MASTER SIGN PLAN APPLICATION

Master Sign Plan as outlined in the Roseville City code section 1010.11 for the building complex planned for 1960, 2020 and 2030 Twin Lakes Parkway.

Re: Walmart Master Sign Plan, 1690 County Road C

Re: Master Sign Plan Submittal

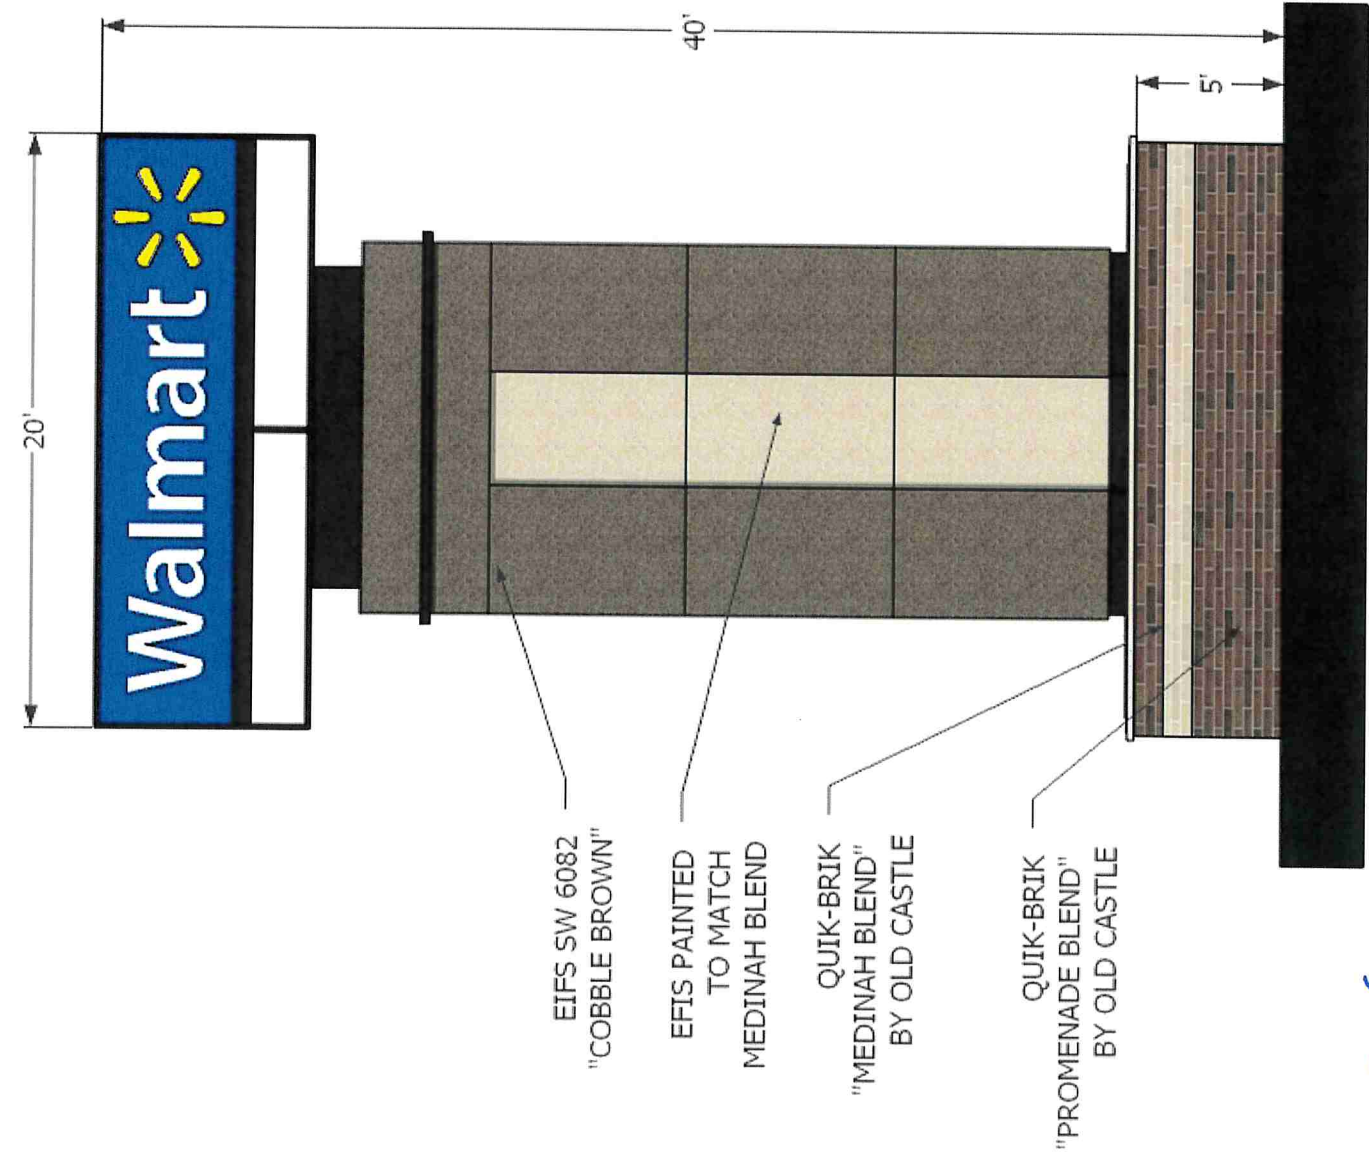
My thought on this proposal is that it is too tall; the other tenant sign areas need to be larger

Yes I would down like to get it closer to 25 feet. Perhaps we can with 40.
